8XC196KD AUTOMOTIVE APPLICATION SPECIFICATION UPDATE

Release Date: July, 1996

Order Number 272839-001

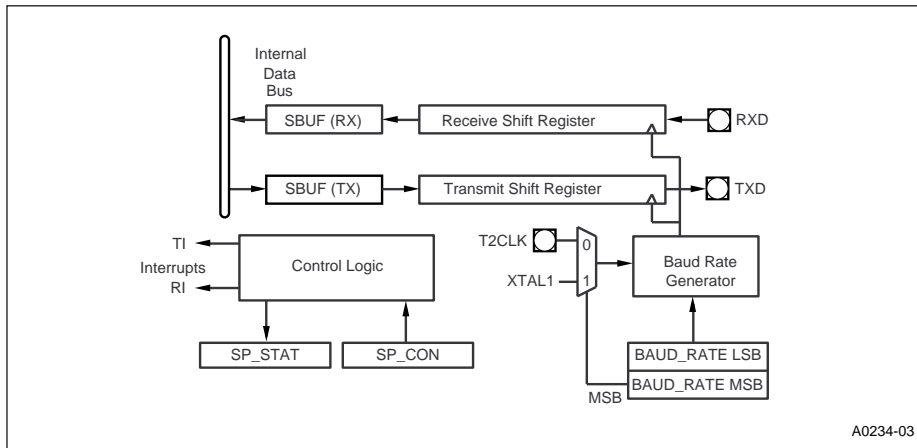
ITEM: On page 10-2, add the following sentences to the second paragraph after the first sentence: 'Since the value written to the control register is buffered, you can write a new 8-bit value to PWMx_CONTROL before the counter overflows. The new value is used during the next period of PWMx.'

The following figure replaces Figure 10-2:

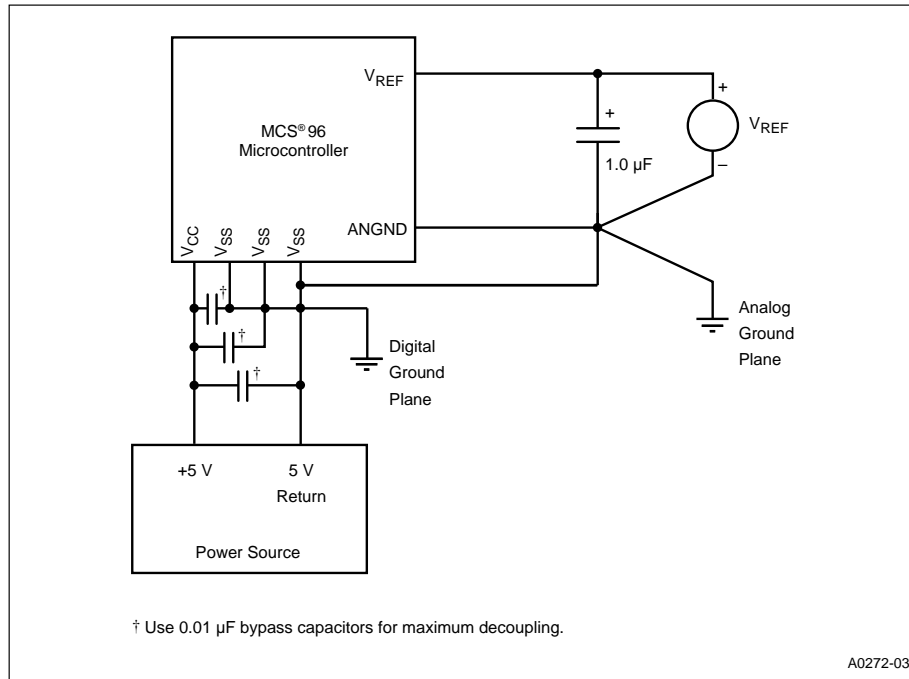
ITEM: In Figure 11-2, the recommended capacitor value between V_{CC} and V_{SS} is **0.01 μF** or greater. Also the recommended capacitor value between V_{REF} and ANGND is **1.0 μF** . The following figure replaces Figure 11-2:

'Connect a 0.01- μF bypass capacitor between V_{CC} and each V_{SS} pin and a 1.0- μF capacitor between V_{REF} and ANGND.'

Figure 11-6. External Clock Drive

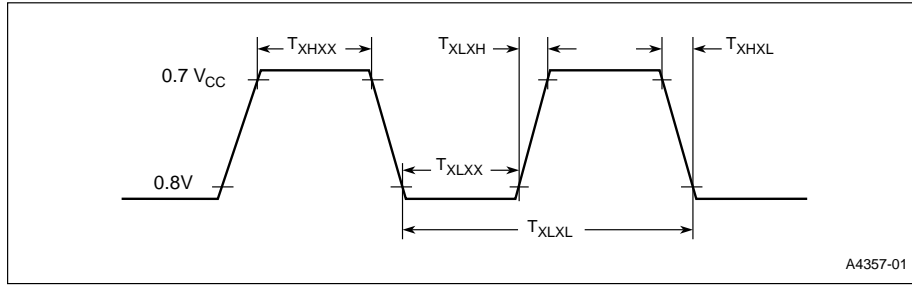
ITEM: In Figure 11-6, the timing diagram incorrectly represents the T_{xkl} and T_{xhkl} timing specifications. The timing diagram below replaces Figure 11-6.

Figure 11-8. Reset Pin Internal Circuit

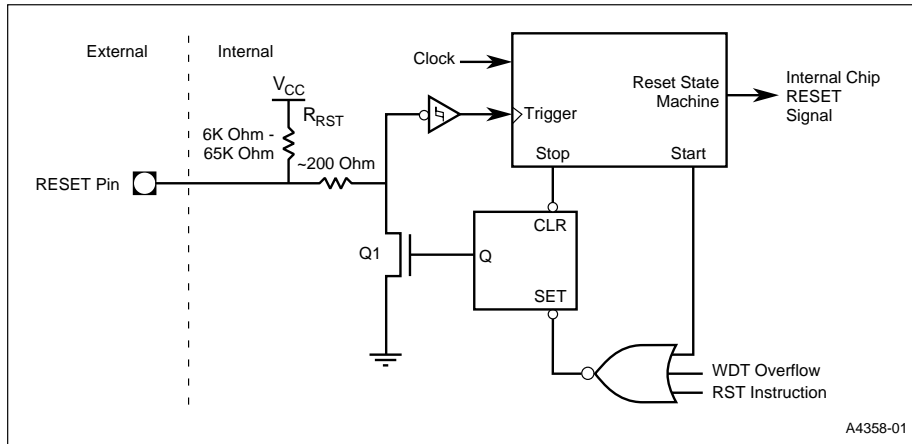
ITEM: Figure 11-8 shows the reset pin internal circuit. However, there are a couple of mistakes; the following figure shows the corrected version. The **inverter** at the Reset State Machines Trigger input and the **OR gate** at the SET input of the latch are the corrections to this figure.
